Change Notice

UB2 Series

Changes for Super Bright Blue LEDs in UB2 Series Pushbuttons & Indicators

CHANGES TO TERMINALS & TERMINAL PLATING		
Model	Before Change	After Change
Snap-in Mount with Solder Lug Terminals Code 01	  	  
PC Mount with Straight PC Terminals Code 03	  	  
Terminal Plating	Tin	Silver

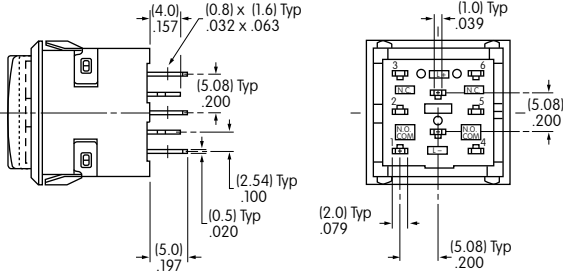
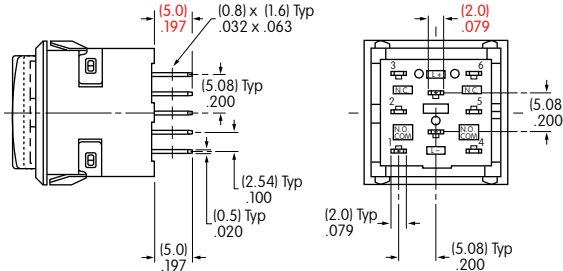
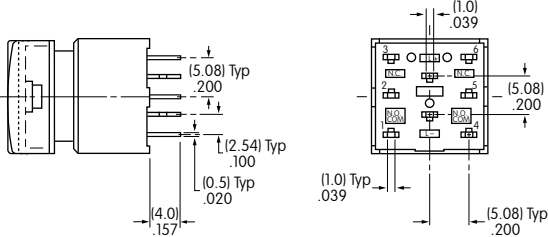
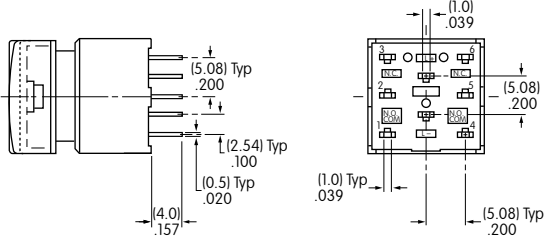
The Super Bright Blue LEDs for UB2 Series pushbutton switches and indicators will be changing. Both standard and custom pushbuttons and indicators are included in the revision. The change will effect electrical specifications, which are compared below. It will also effect the LED terminal dimensions and terminal plating, displayed on page 2. Part numbers for effected standard switches and indicators are shown on page 3.
